Attachment 3

**Proposed Technical Specification Bases Changes (Mark-up)
(For Information Only)**

SR 3.4.7.1

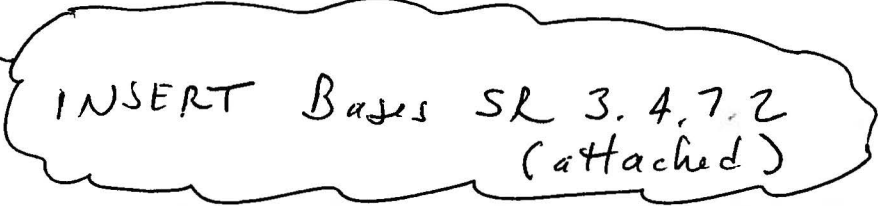
INSERT Bases SR 3.4.7.2
(attached)

INSERT Bases SR 3.4.7.2

SR 3.4.7.2

RHR Shutdown Cooling System piping and components have the potential to develop voids and pockets of entrained gases. Preventing and managing gas intrusion and accumulation is necessary for proper operation of the RHR shutdown cooling subsystems and may also prevent water hammer, pump cavitation, and pumping of noncondensable gas into the reactor vessel.

Selection of RHR Shutdown Cooling System locations susceptible to gas accumulation is based on a review of system design information, including piping and instrumentation drawings, isometric drawings, plan and elevation drawings, and calculations. The design review is supplemented by system walk downs to validate the system high points and to confirm the location and orientation of important components that can become sources of gas or could otherwise cause gas to be trapped or difficult to remove during system maintenance or restoration. Susceptible locations depend on plant and system configuration, such as stand-by versus operating conditions.

The RHR Shutdown Cooling System is OPERABLE when it is sufficiently filled with water. Acceptance criteria are established for the volume of accumulated gas at susceptible locations. If accumulated gas is discovered that exceeds the acceptance criteria for the susceptible location (or the volume of accumulated gas at one or more susceptible locations exceeds an acceptance criteria for gas volume at the suction or discharge of a pump), the Surveillance is not met. If it is determined by subsequent evaluation that the RHR Shutdown Cooling System is not rendered inoperable by the accumulated gas (i.e., the system is sufficiently filled with water), the Surveillance may be declared met. Accumulated gas should be eliminated or brought within the acceptance criteria limits. If the accumulated gas is eliminated or brought within the acceptance criteria limits as part of the Surveillance performance, the Surveillance is considered met and the system is OPERABLE. Past operability is then evaluated under the Corrective Action program. If it is suspected that a gas intrusion event is occurring, then this is evaluated under the Operability Determination Process.

Gas accumulation in the RHR shutdown cooling (SDC) suction flow path is satisfactorily addressed by procedures which fill the system prior to placing SDC in service. Since the non-safety shutdown cooling mode of RHR is manually initiated at a low reactor pressure, sufficient time is available to ensure fill and warm-up of the flow path have been performed prior to starting an RHR pump, thereby avoiding any unacceptable pressure transients on the system.

RHR Shutdown Cooling System locations susceptible to gas accumulation are monitored and, if gas is found, the gas volume is compared to the acceptance criteria for the location. Susceptible locations in the same system flow path which are subject to the same gas intrusion mechanisms may be verified by monitoring a representative sub-set of susceptible locations. Monitoring may not be practical for locations that are inaccessible due to radiological or environmental conditions, the plant configuration, or personnel safety. For these locations alternative methods (e.g., operating parameters, remote monitoring) may be used to monitor the susceptible location. Monitoring is not required for susceptible locations where the maximum potential accumulated gas void volume has been evaluated and determined to not challenge system OPERABILITY. The accuracy of the method used for monitoring the susceptible locations and trending of the results should be sufficient to assure system OPERABILITY during the Surveillance interval.

This SR is modified by a Note that states the SR is not required to be performed until 12 hours after reactor steam dome pressure is less than the RHR shutdown cooling isolation pressure. In a rapid shutdown, there may be insufficient time to verify all susceptible locations prior to entering the Applicability.

The 31 day Frequency takes into consideration the gradual nature of gas accumulation in the RHR Shutdown Cooling System piping and the procedural controls governing system operation.

SR 3.4.8.1

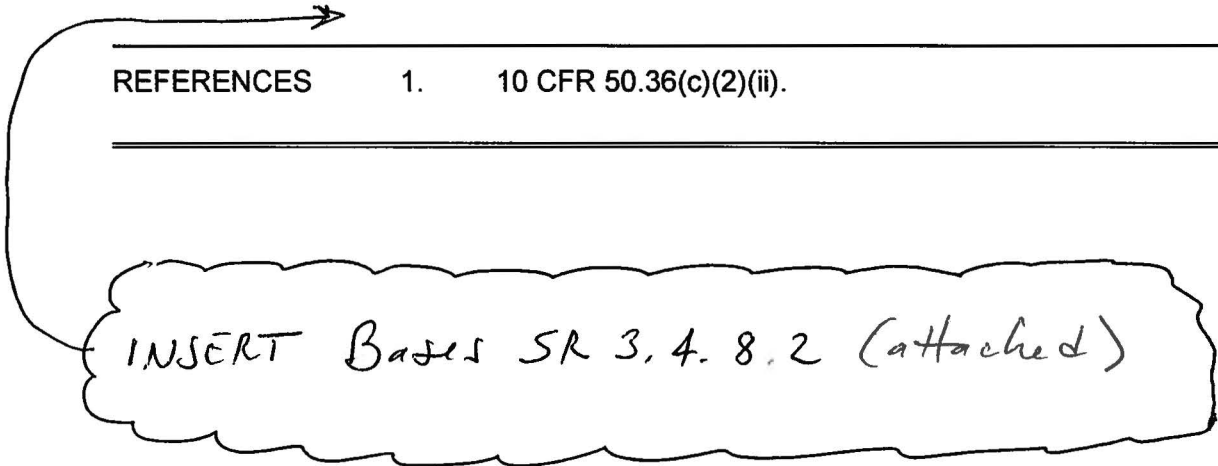
INSERT Bases SR 3.4.8.2 (attached)

INSERT Bases SR 3.4.8.2

SR 3.4.8.2

RHR Shutdown Cooling System piping and components have the potential to develop voids and pockets of entrained gases. Preventing and managing gas intrusion and accumulation is necessary for proper operation of the RHR shutdown cooling subsystems and may also prevent water hammer, pump cavitation, and pumping of noncondensable gas into the reactor vessel.

Selection of RHR Shutdown Cooling System locations susceptible to gas accumulation is based on a review of system design information, including piping and instrumentation drawings, isometric drawings, plan and elevation drawings, and calculations. The design review is supplemented by system walk downs to validate the system high points and to confirm the location and orientation of important components that can become sources of gas or could otherwise cause gas to be trapped or difficult to remove during system maintenance or restoration. Susceptible locations depend on plant and system configuration, such as stand-by versus operating conditions.

The RHR Shutdown Cooling System is OPERABLE when it is sufficiently filled with water. Acceptance criteria are established for the volume of accumulated gas at susceptible locations. If accumulated gas is discovered that exceeds the acceptance criteria for the susceptible location (or the volume of accumulated gas at one or more susceptible locations exceeds an acceptance criteria for gas volume at the suction or discharge of a pump), the Surveillance is not met. If it is determined by subsequent evaluation that the RHR Shutdown Cooling System is not rendered inoperable by the accumulated gas (i.e., the system is sufficiently filled with water), the Surveillance may be declared met. Accumulated gas should be eliminated or brought within the acceptance criteria limits. If the accumulated gas is eliminated or brought within the acceptance criteria limits as part of the Surveillance performance, the Surveillance is considered met and the system is OPERABLE. Past operability is then evaluated under the Corrective Action program. If it is suspected that a gas intrusion event is occurring, then this is evaluated under the Operability Determination Process.

Gas accumulation in the RHR shutdown cooling (SDC) suction flow path is satisfactorily addressed by procedures which fill the system prior to placing SDC in service. Since the non-safety shutdown cooling mode of RHR is manually initiated at a low reactor pressure, sufficient time is available to ensure fill and warm-up of the flow path have been performed prior to starting an RHR pump, thereby avoiding any unacceptable pressure transients on the system.

RHR Shutdown Cooling System locations susceptible to gas accumulation are monitored and, if gas is found, the gas volume is compared to the acceptance criteria for the location. Susceptible locations in the same system flow path which are subject to the same gas intrusion mechanisms may be verified by monitoring a representative sub-set of susceptible locations. Monitoring may not be practical for locations that are inaccessible due to radiological or environmental conditions, the plant configuration, or personnel safety. For these locations alternative methods (e.g., operating parameters, remote monitoring) may be used to monitor the susceptible location. Monitoring is not required for susceptible locations where the maximum potential accumulated gas void volume has been evaluated and determined to not challenge system OPERABILITY. The accuracy of the method used for monitoring the susceptible locations and trending of the results should be sufficient to assure system OPERABILITY during the Surveillance interval.

The 31 day Frequency takes into consideration the gradual nature of gas accumulation in the RHR Shutdown Cooling System piping and the procedural controls governing system operation.

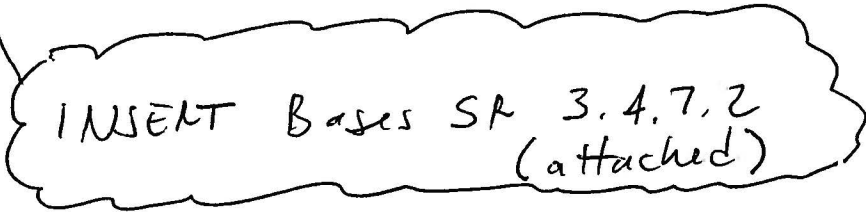
INSERT Bases SR 3.4.7.2
(attached)

Selection of RHR Shutdown Cooling System locations susceptible to gas accumulation is based on a review of system design information, including piping and instrumentation drawings, isometric drawings, plan and elevation drawings, and calculations. The design review is supplemented by system walk downs to validate the system high points and to confirm the location and orientation of important components that can become sources of gas or could otherwise cause gas to be trapped or difficult to remove during system maintenance or restoration. Susceptible locations depend on plant and system configuration, such as stand-by versus operating conditions.

RHR Shutdown Cooling System locations susceptible to gas accumulation are monitored and, if gas is found, the gas volume is compared to the acceptance criteria for the location. Susceptible locations in the same system flow path which are subject to the same gas intrusion mechanisms may be verified by monitoring a representative sub-set of susceptible locations. Monitoring may not be practical for locations that are inaccessible due to radiological or environmental conditions, the plant configuration, or personnel safety. For these locations alternative methods (e.g., operating parameters, remote monitoring) may be used to monitor the susceptible location. Monitoring is not required for susceptible locations where the maximum potential accumulated gas void volume has been evaluated and determined to not challenge system OPERABILITY. The accuracy of the method used for monitoring the susceptible locations and trending of the results should be sufficient to assure system OPERABILITY during the Surveillance interval.

This SR is modified by a Note that states the SR is not required to be performed until 12 hours after reactor steam dome pressure is less than the RHR shutdown cooling isolation pressure. In a rapid shutdown, there may be insufficient time to verify all susceptible locations prior to entering the Applicability.

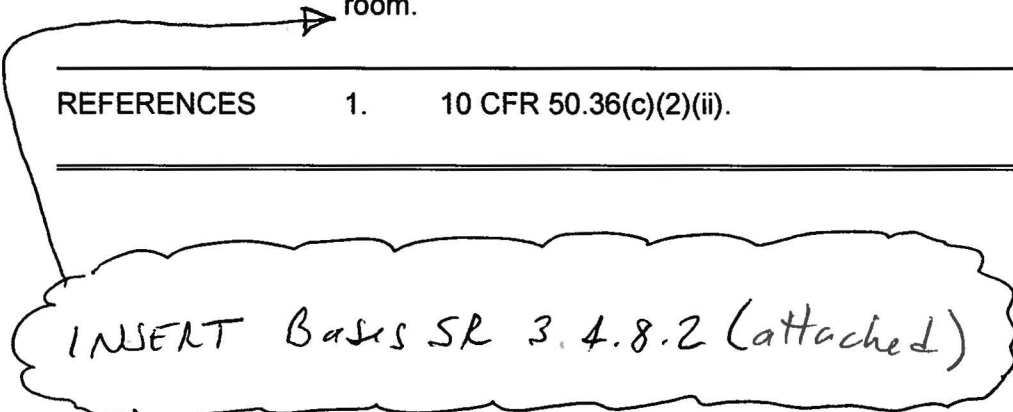
INSERT Bases SR 3.4.8.2 (attached)
